ABOUT ADSP-21362 SILICON ANOMALIES

NR003081J

6. 07000019 - Input Shift Register Anomaly in ASRCs (Asynchronous Sample Rate Converters) impacts Daisy-Chained TDM mode:

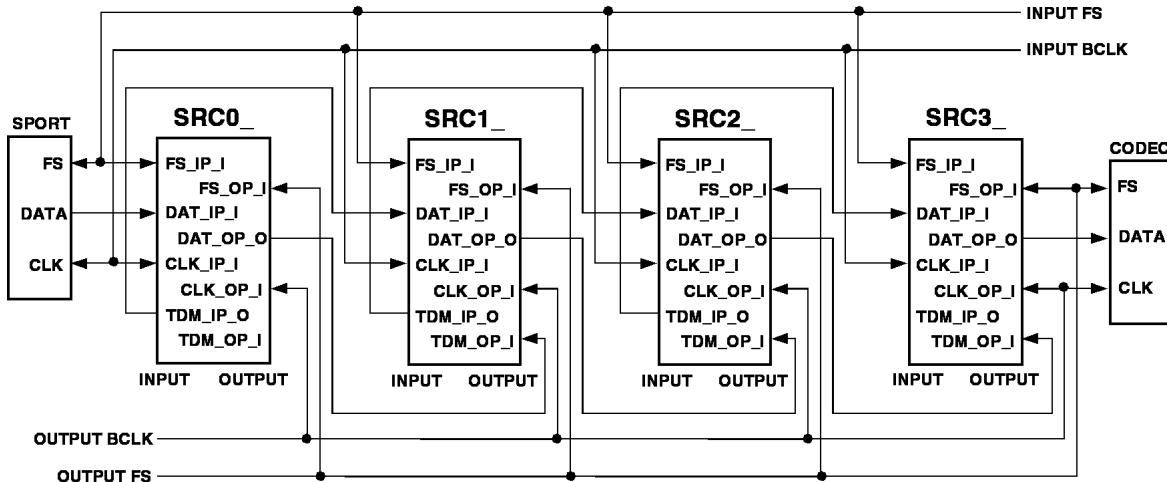
In the TDM Daisy chaining mode the ASRCs can be connected as follows to achieve TDM mode:

Each ASRC has two 64-bit shift registers (one for the input side, and the other for the output side). When the ASRCs are daisy-chained, these 64-bit registers can be thought of as a single long shift register, which holds an entire frame of data.

When the ASRCs are used in TDM Daisy chaining mode, the MSB of the input data is lost at the output of each ASRC in the chain. This anomaly is applicable for the TDM mode in both the bypass and non-bypass modes. The following example provides the expected failure pattern for the bypass mode, since in bypass mode the incoming data is not modified by the ASRC.

For a TDM daisy chain with 8 channels in BYPASS mode, the output of the final ASRC in the chain will result in three-bit left shift for the channels 1 and 2, two bit left shift for the channels 3 and 4 and one bit left shift for the channels 5 and 6. The channels 7 and 8 will not have any data shift. At the output end, three MSBs will be lost for the channels 1 and 2, two MSBs will be lost for the channels 3 and 4 and

The workaround for this anomaly must be carried out in the software, only on the input data to the ASRCs in TDM daisy chaining mode. It can not be implemented on the output data from the ASRCs. The workaround implementation in the software adds some core MIPS to the application. For the devices like ADC/CODECs the workaround may not be implemented directly. For such systems, two serial ports of the processor should be dedicated for this purpose. One serial port should be used for receiving the data from the ADC/CODEC and the other one should be used for transmitting the modified input data to the ASRC.

When the ASRCs are used in TDM daisy chaining mode, only the 24-MSBs of the input 32-bit data is used and the 8-LSBs are not used by the ASRC. The anomaly can be workaround by shifting the 24-MSBs of the data to the 8-LSBs as follows:
